OSID-Range - Erratum

February 2021

Conventional: OSI-R, OSI-RA, OSI-R-SS, OSI-RA-SS

Intelligent: OSI-RI-SS, OSI-RIA-SS, OSI-RI-FL, FS-OSI-RI, FS-OSI-RIA, OSI-RI-FH, OSI-RI-GW, OSI-RI-SK

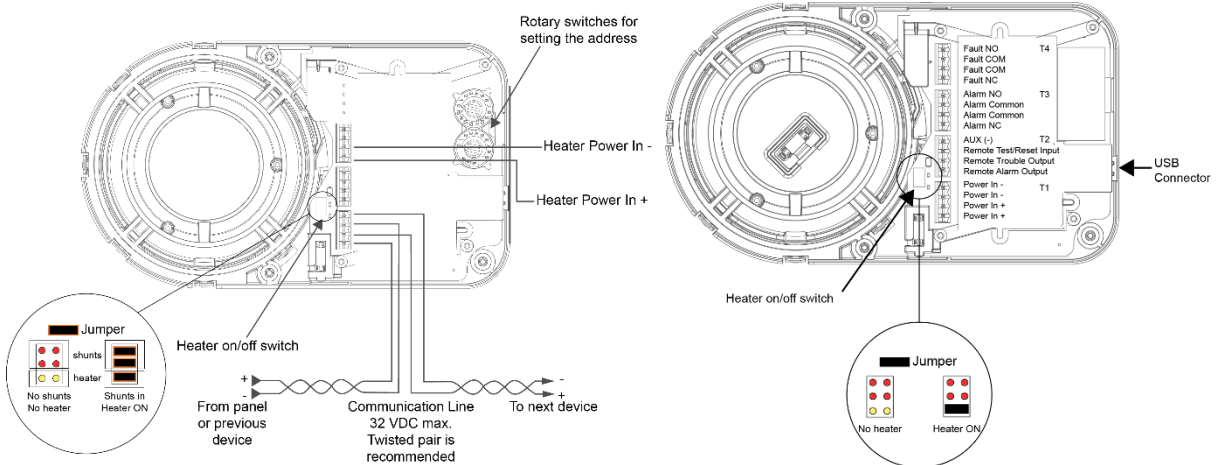
Wiring drawing errors in the Product Guides and Quick Start Guides of the concerned products has been discovered. Specifically, a jumper position switch between isolator settings and the heater setting in the wiring diagrams.

Wrong jumper settings:

The field correction, if the jumper(s) were applied at all, can simply be executed at a next service call.

Correct jumper settings:
